CHAPTER 4

DESIGN REVIEW PANEL NO.2
OCTOBER 2021

PLANNING PRE-APPLICATION

DRP NO. 2 Responses

Previously Presented DRP 2 Scheme

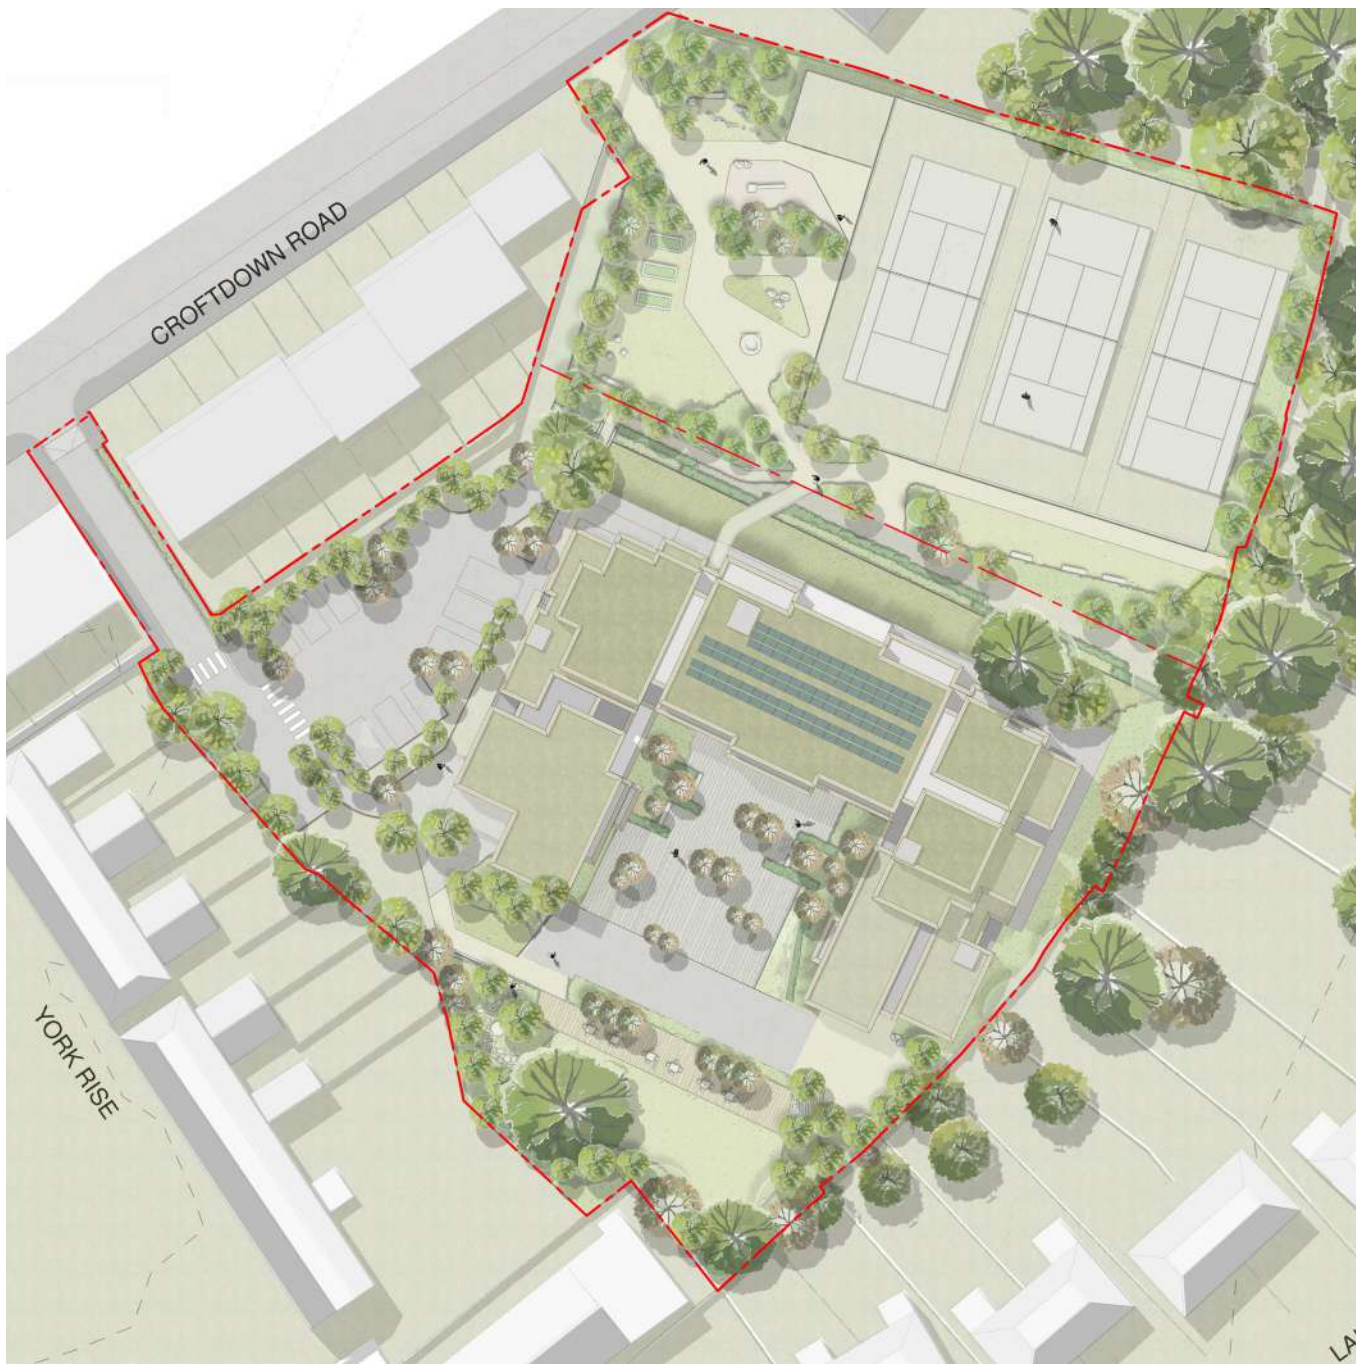
1. Mass and form to be broken up and articulated more positively;
2. Visual connections improved;
3. Connection between north and south to be re-designed.

1. Building form has been further broken up at all levels offering a more interesting, playful facade;
2. Areas of brick detailing integrated;
3. Physical and visual connections improved;
4. Glazing extents and positioning amended.

Revised 1st Floor

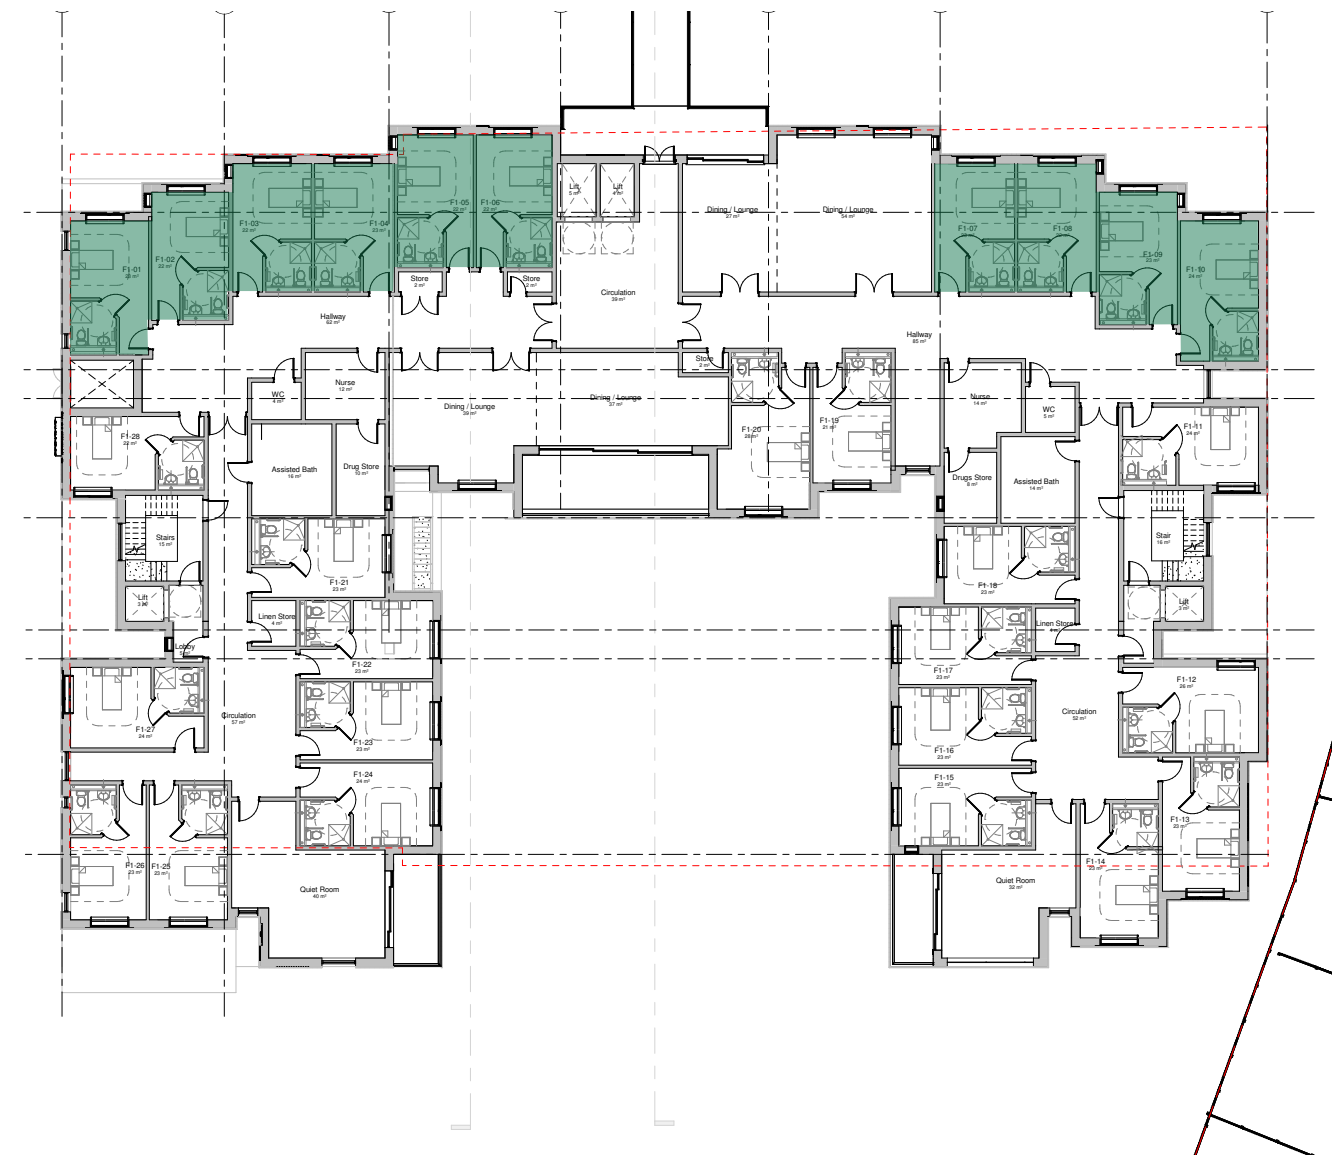
1. Institutional Feeling scheme, not consistent with conservation area;
2. Visual connections improved;
3. North facing and single aspect units to be reduced.

1. Improved building articulation;
2. Dual aspect northern apartments;
3. Physical and visual connections improved;
4. North-facing units reduced from 12 to 10.

Revised 1st Floor

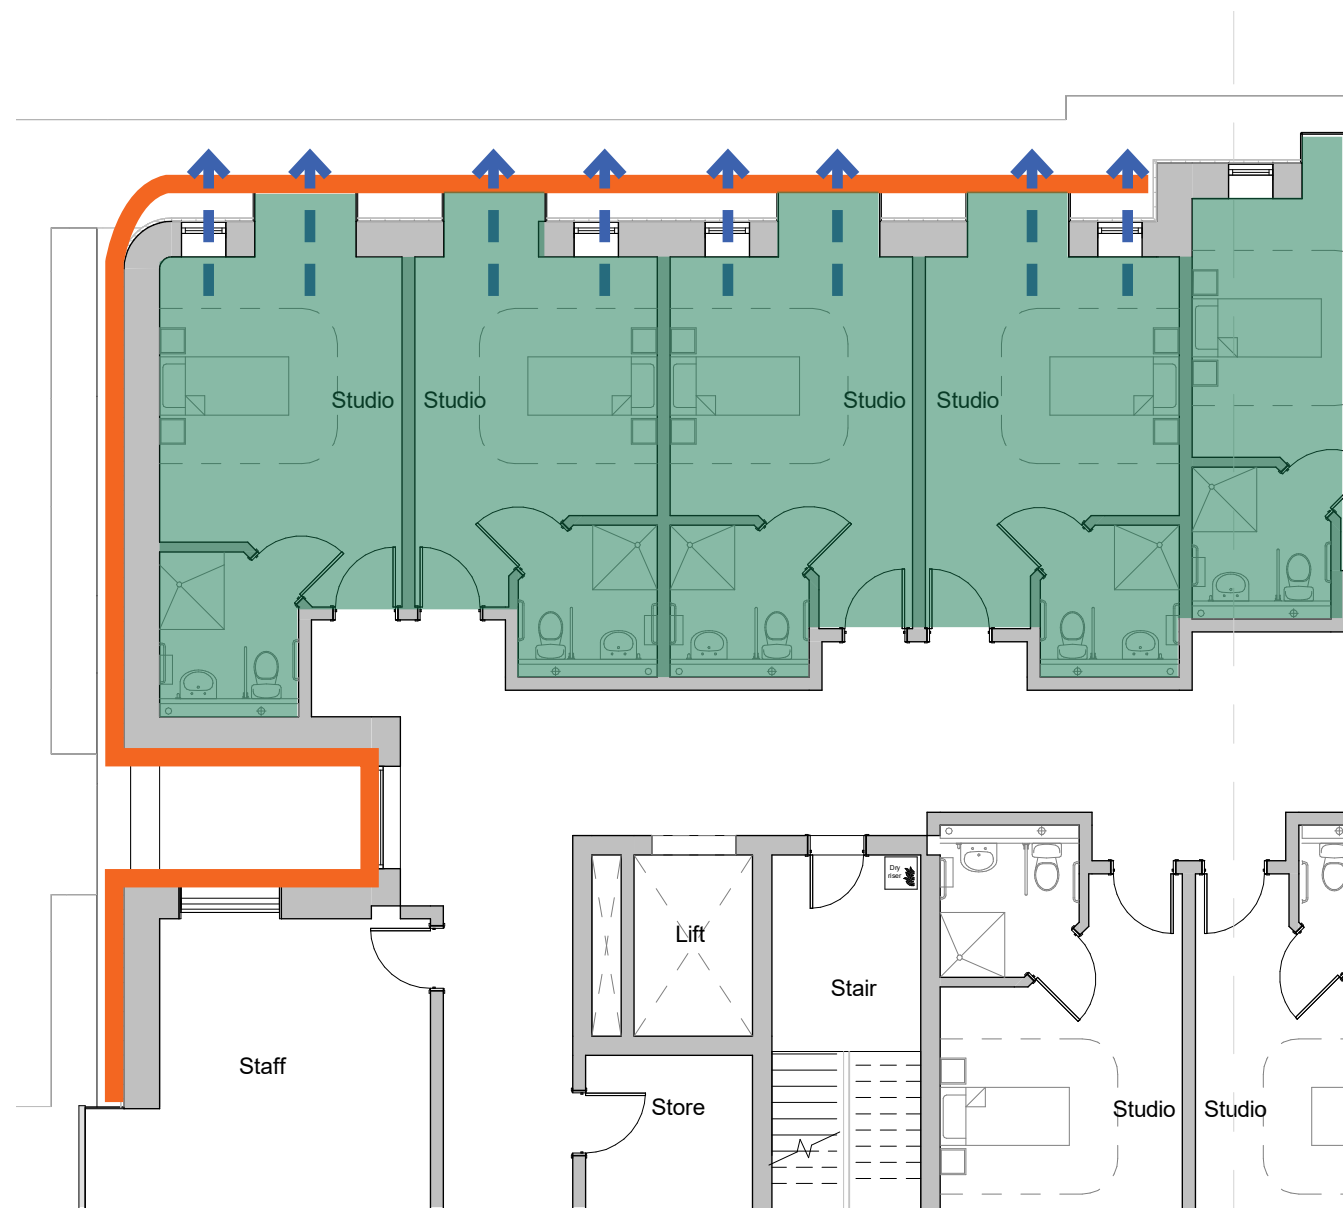
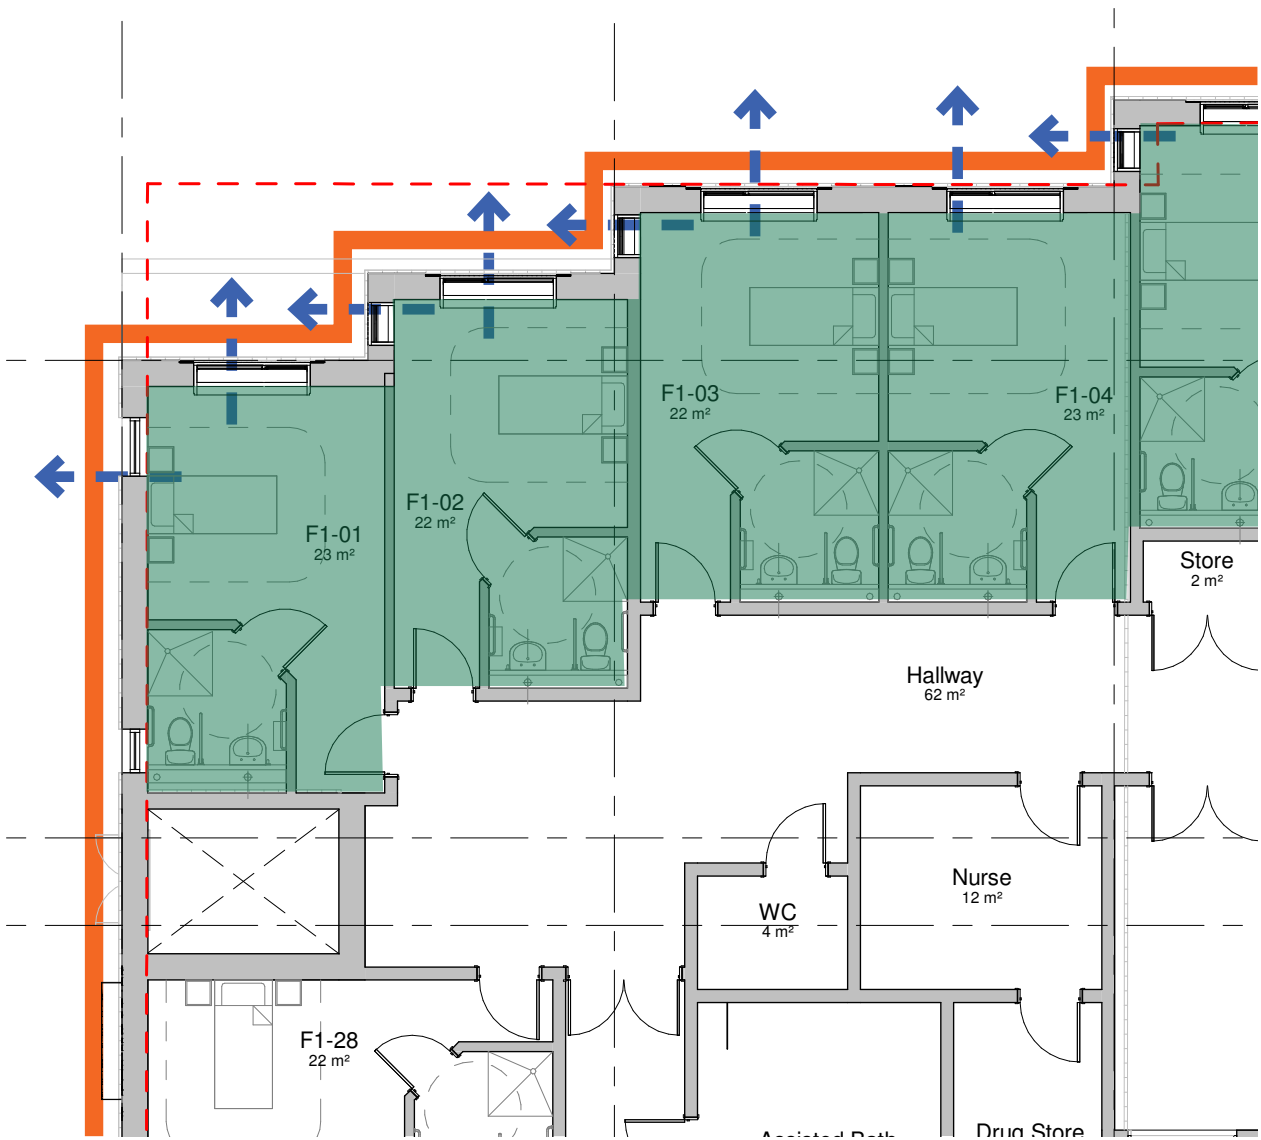
- 1. Institutional Feeling scheme, not consistent with conservation area;
- 2. Visual connections improved;
- 3. North facing and single aspect units to be reduced.

- 1. Improved building articulation;
- 2. Dual aspect northern apartments;
- 3. Physical and visual connections improved.
